CITY OF DULUTH

Community Planning Division

File Number	PL17-036	Contact	John Kelley, 218-730-5326	
Type	Variance, Rear Side Yard Setback	Planning Commission Date		April 11, 2017
Deadline for Action	Application Date	March 6, 2017	60 Days	May 5, 2017
	Date Extension Letter Mailed	March 20, 2017	120 Days	July 4, 2017
Location of Subject		3421 East 1 st Street		
Applicant	James Mohn and Heather Muster	Contact	3421 East 1 st Street	
Agent	CF Designs (Jeremy Jones)	Contact	230 East Superior Street	
Legal Description		010-1370-00800		
Site Visit Date		March 31, 2017	Sign Notice Date	
			March 28, 2017	
Neighbor Letter Date		March 27, 2017	Number of Letters Sent	
			32

A variance to construct a screen porch addition and deck to the rear yard of the house that will encroach 10.5 feet into the rear yard setback.

1 SITE PLAN
SCALE: 1/16" = 1'-0"

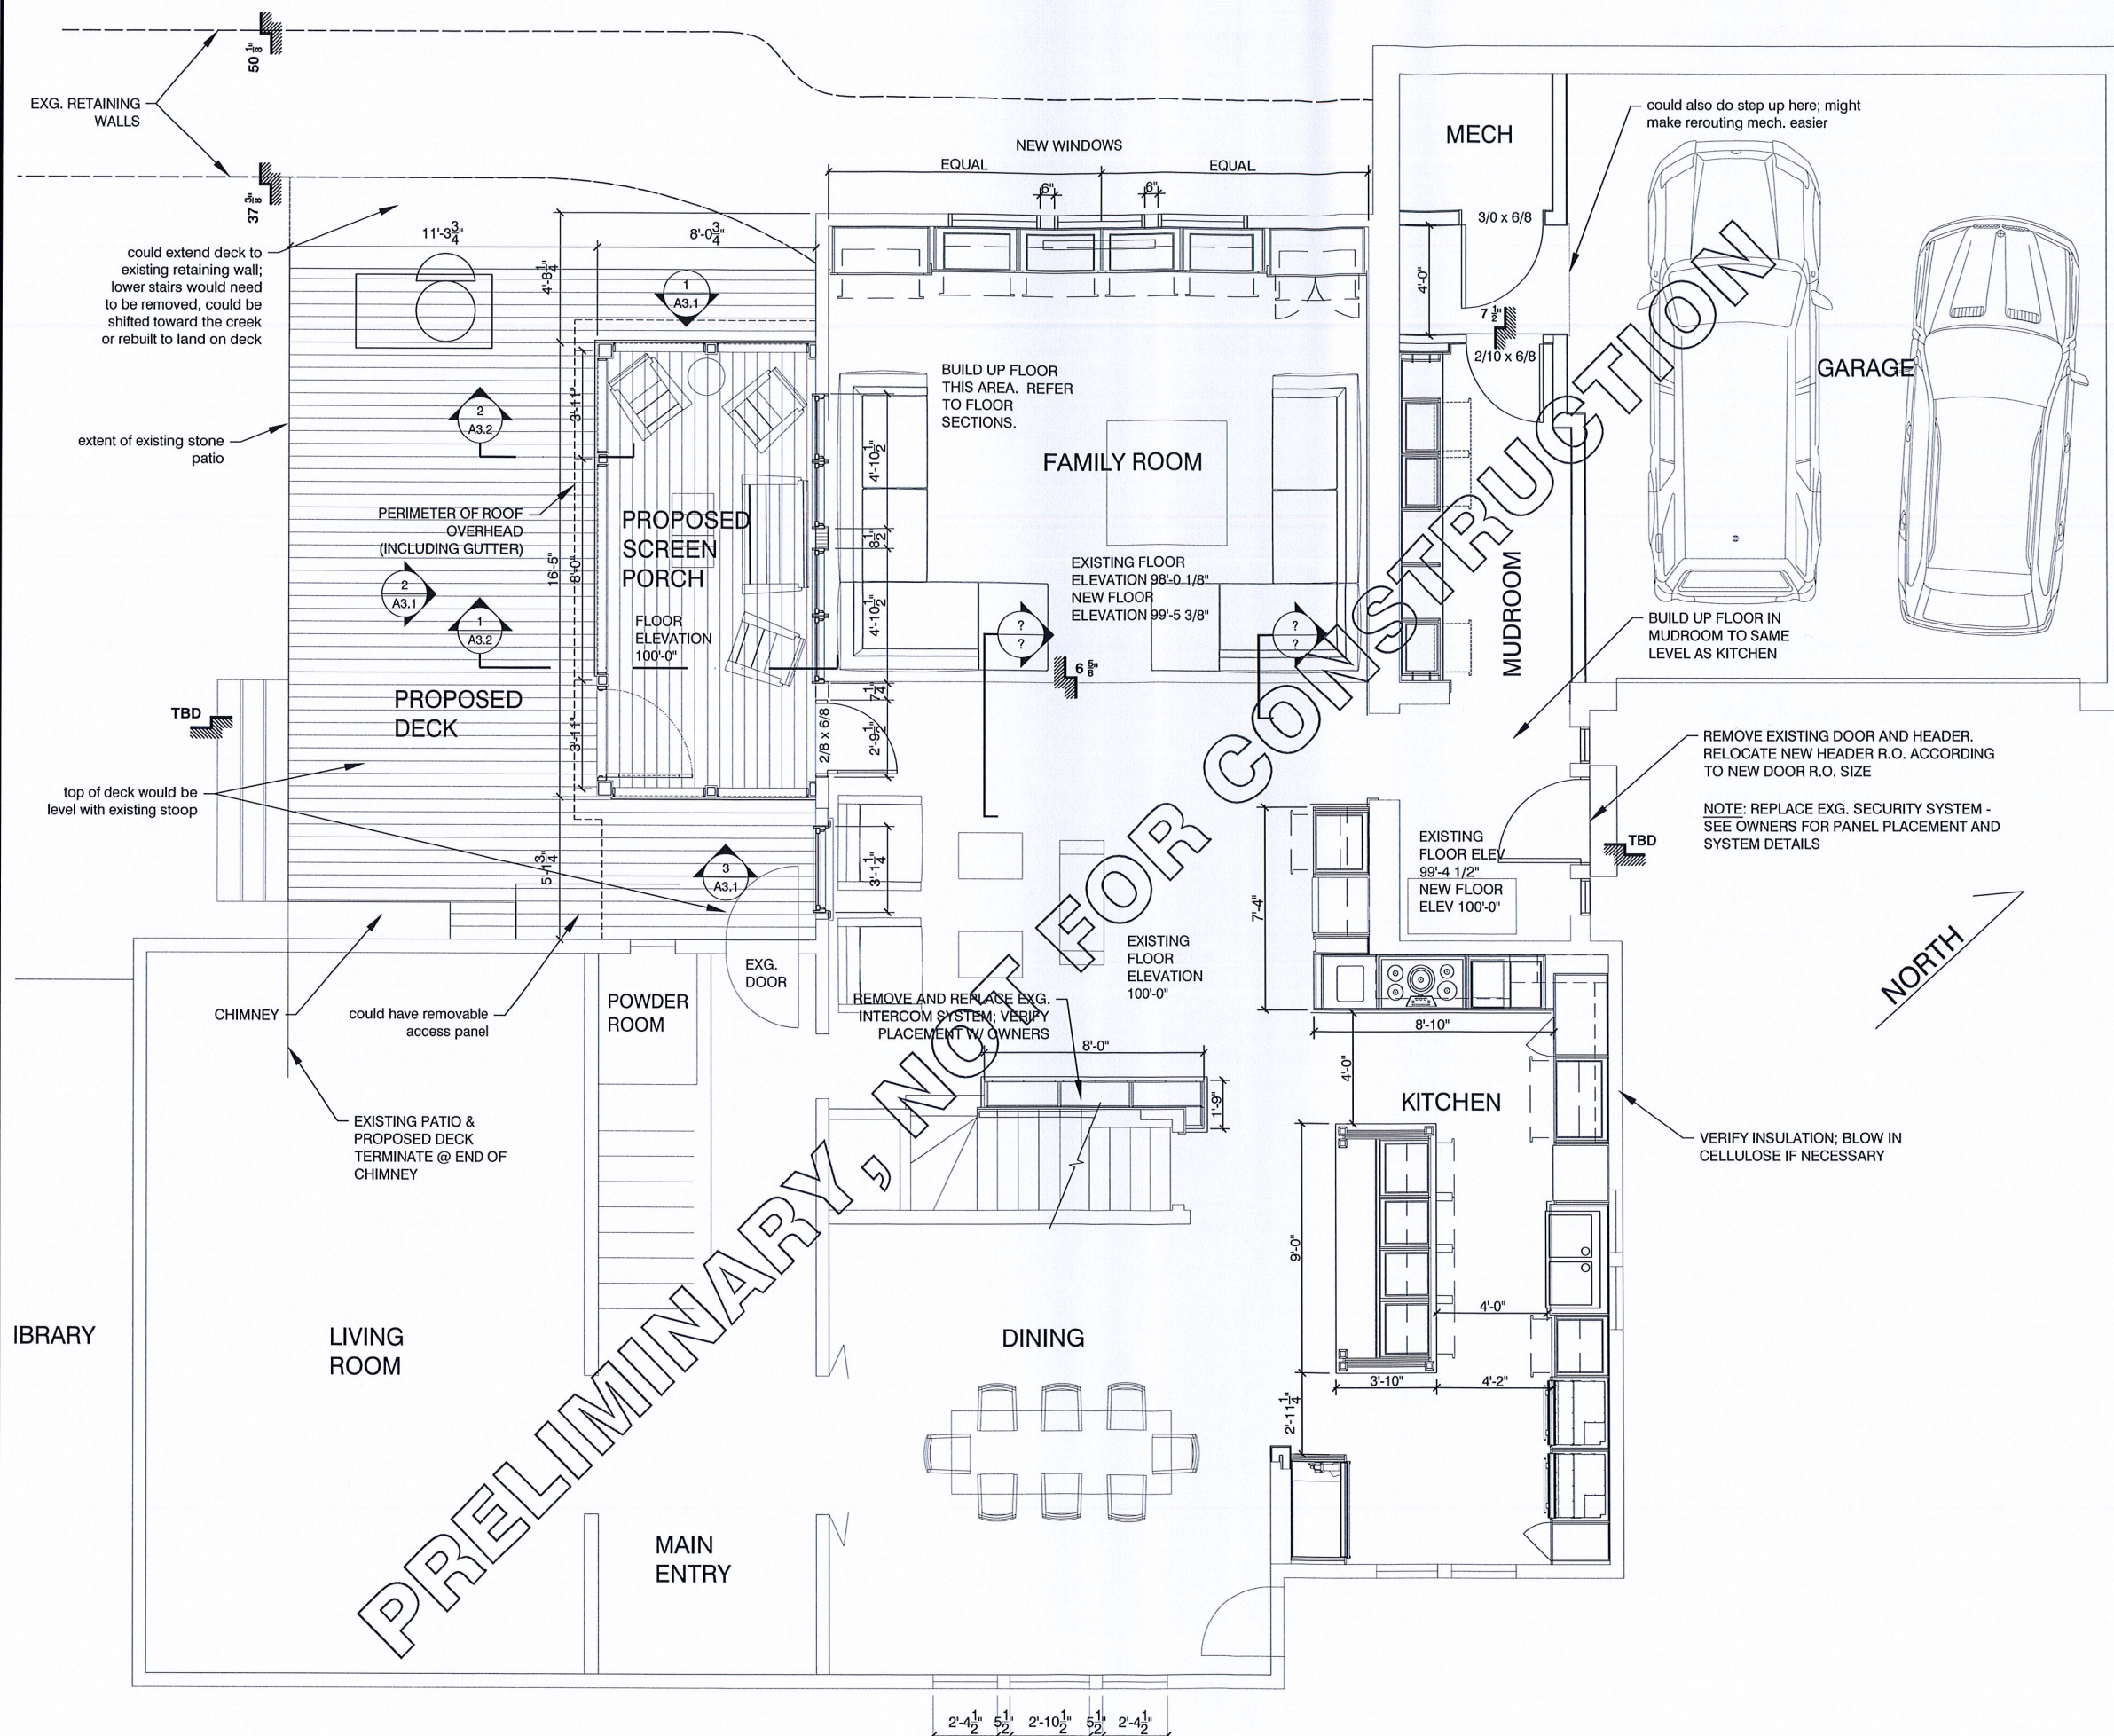
- 5) Staff finds there are alternatives for constructing the screen porch and deck that wouldn't require a setback variance. The proposed screen porch and deck could be reconfigured and constructed to fit within the area west of the patio doors. This area would allow for a reasonably sized screen porch and deck to achieve the objectives of the applicant. Therefore, staff finds that there aren't practical difficulties or hardship involved in adhering to the normal setbacks for the property. The need for the variance is caused by the applicant's desire to add on to the home in a particular manner and is not caused by the shape of the lot or its inherent topography.

Based on the above findings, staff finds that the standard for variance has not been met and, therefore, recommends the Planning Commission deny the requested variance because there aren't practical difficulties or hardship caused by adhering to the normal setbacks for the property. There is reasonable space to construct a screen porch and deck outside the setback and that the need for the variance is caused by the applicant's desire to add on to the home in a particular manner and is not caused by the shape of the lot or its inherent topography.

Staff also finds that, should the Planning Commission find reason to grant the variance, neither the essential character of the area nor the purpose and intent of the UDC or Comprehensive Plan will be compromised by the variance. Additionally, if the Planning Commission decides to grant the variance, staff recommends that the variance be limited to the project shown on Sheet S2.0 prepared by cf design ltd dated 12/9/2015.
